# Report of the CAA's Post Implementation Review of London Luton Airport's Airspace Change Proposal - Runway 26 Brookmans Park RNAV-1 Standard Instrument Departure Procedures

CAP 1882

Figure 1 – 2017 average maximum Sound Level by Aircraft Type in South Luton

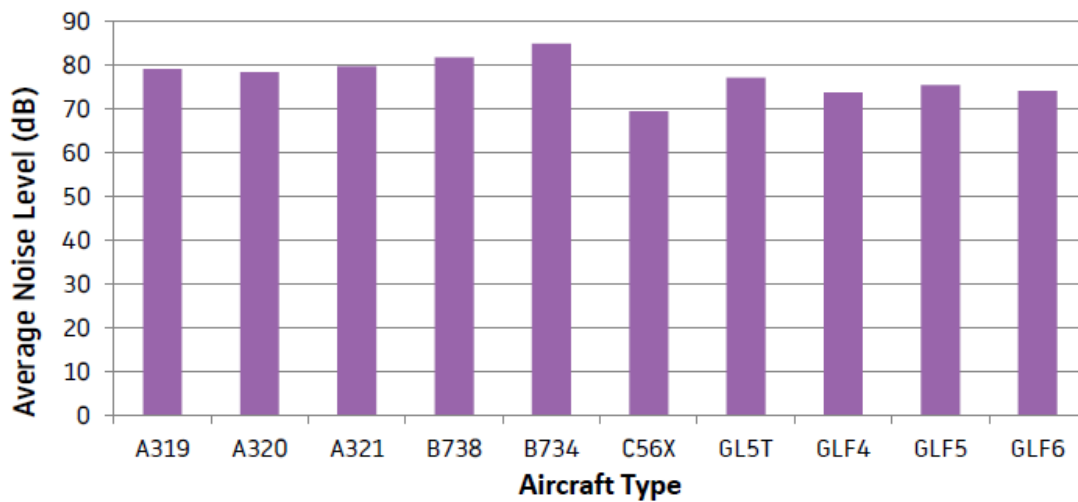
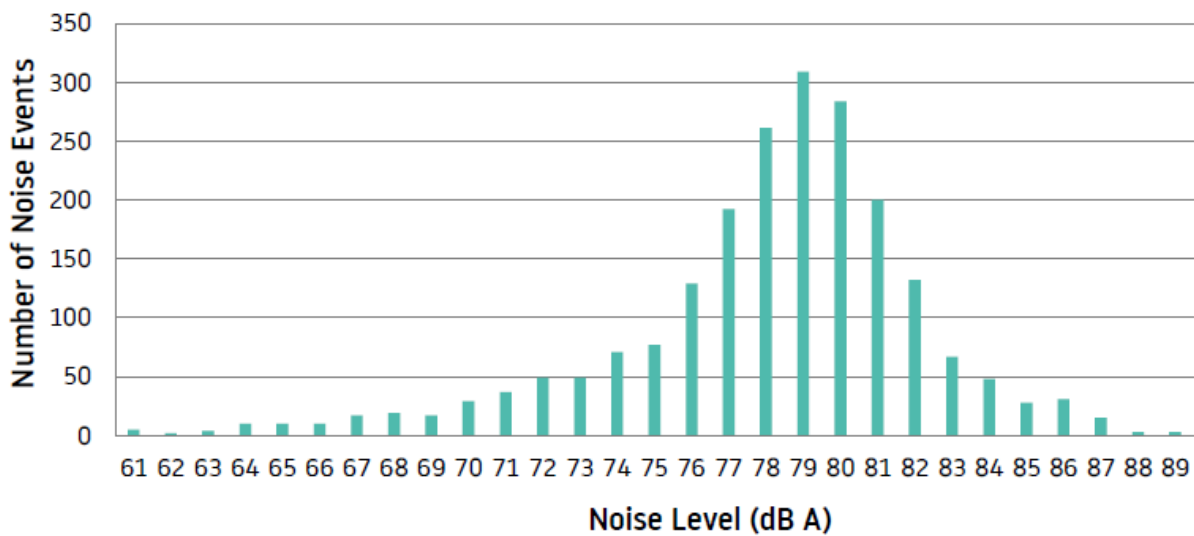
110. When compared with average L<sub>max</sub> noise level before the change and presented earlier in **Table 7**, it can be seen that the A320 (the most frequently operating aircraft) has reduced by 0.1 dB from 78.5 dB in 2015 to 78.4 dB in 2017. In addition to Airbus A320 noise monitoring shown in Table 3, **Figure 1** of [Annex F](#) shows the average L<sub>max</sub> noise level for various aircraft type and **Figure 2** of **Annex F** shows a histogram of L<sub>max</sub> sound levels. The figures show that the average L<sub>max</sub> noise level for the next most frequently operated aircraft, the Airbus A319 was 79 dB and therefore consistent with the average pre-implementation L<sub>max</sub> reported in the formal submission. It is therefore concluded that the minor SID design has been successful in its aims and has not resulted in an increase of aircraft noise in South Luton.

Figure 3 - 2014 average maximum Sound Level by Aircraft Type in Sandridge

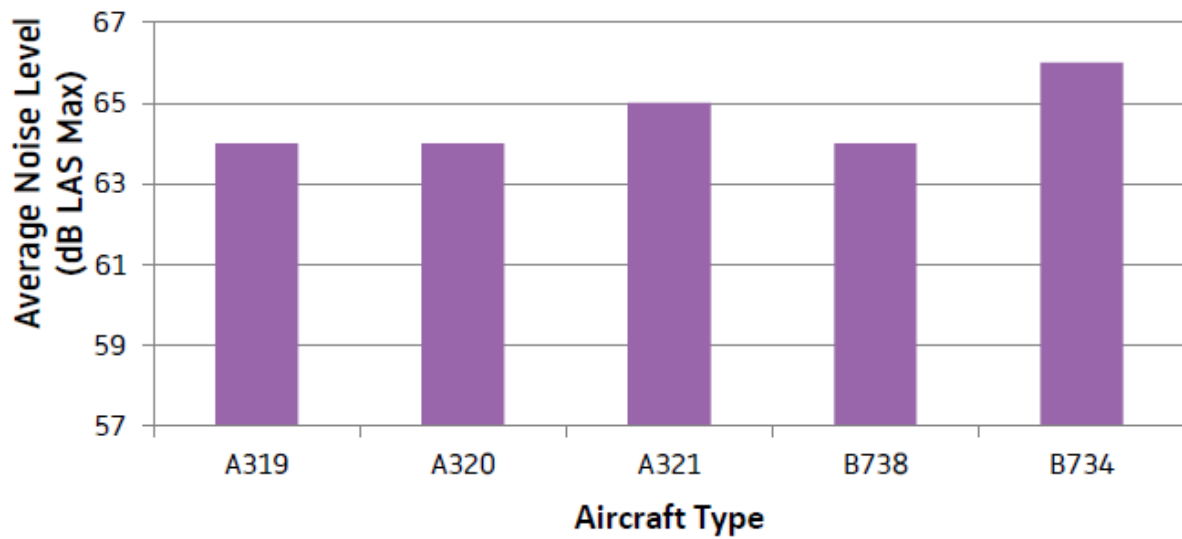
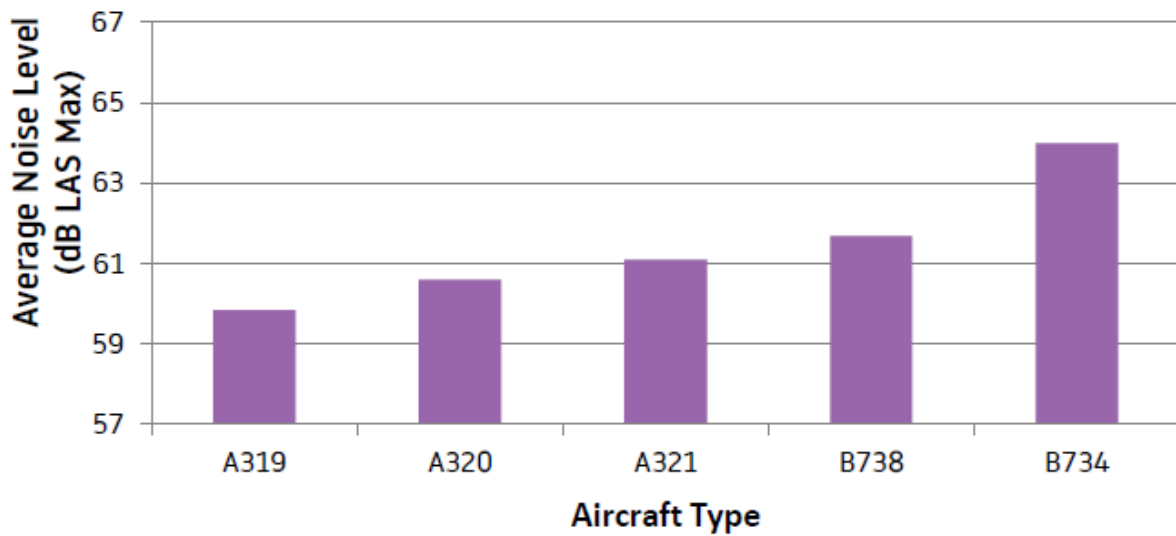
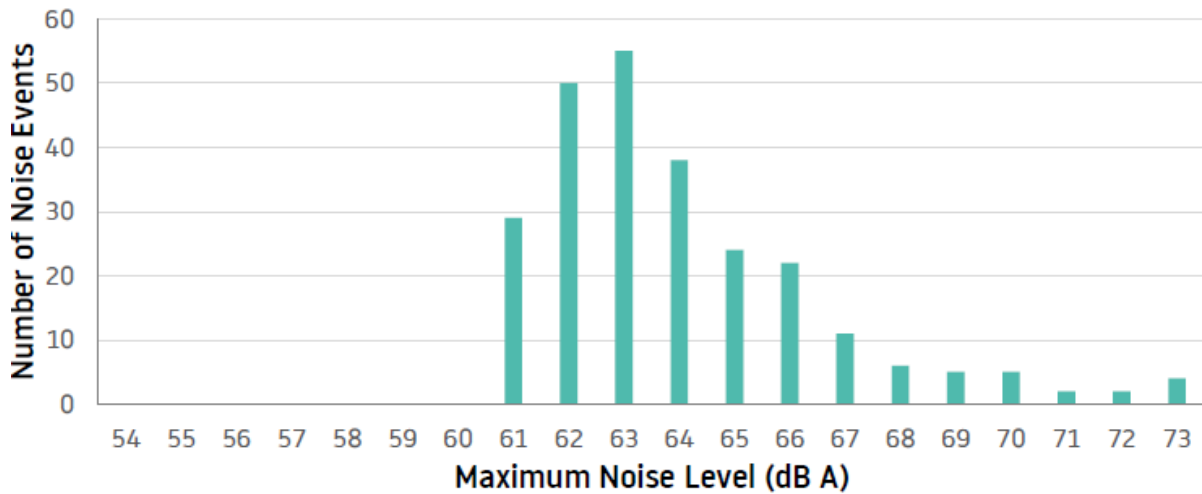
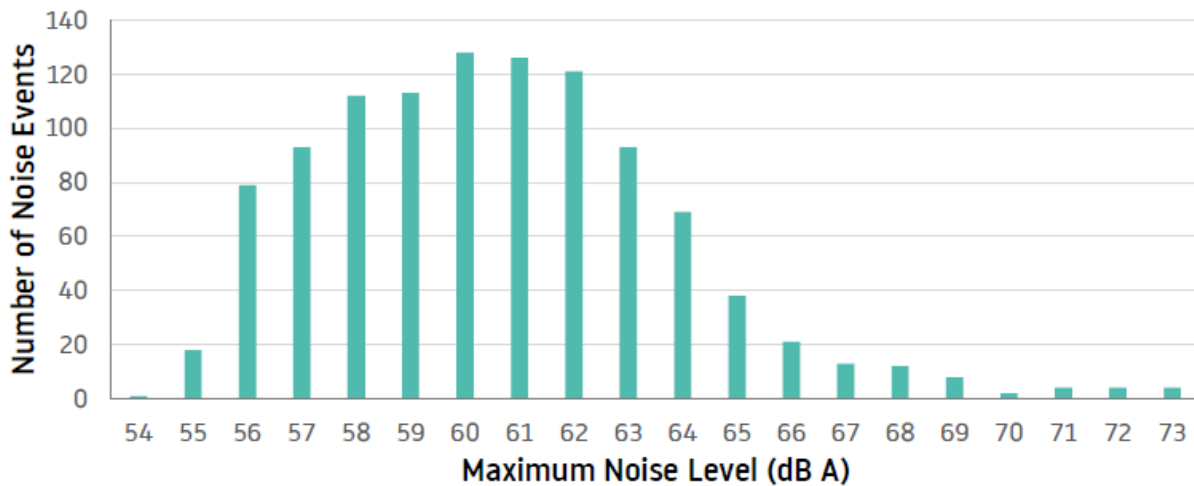
115. The results provided by LLAOL show that in 2017, the most frequently operating aircraft was the Airbus A320, which is consistent with that used within the formal submission. However, the noisiest aircraft in 2017 was the Boeing 737-400, however, this is because the A300 which was used in the formal submission is no longer operating.

- For the A320 the result show that the noise level has reduced by 3.1 dB from 63.6 dB in 2014 to 60.5 dB in 2017 and noise levels for the Boeing 737-400 have reduced by 1.6 dB from 65.6 dB in 2014 to 64.0 dB in 2017. It is therefore concluded that there has been no increase in aircraft noise in Sandridge because of this ACP.
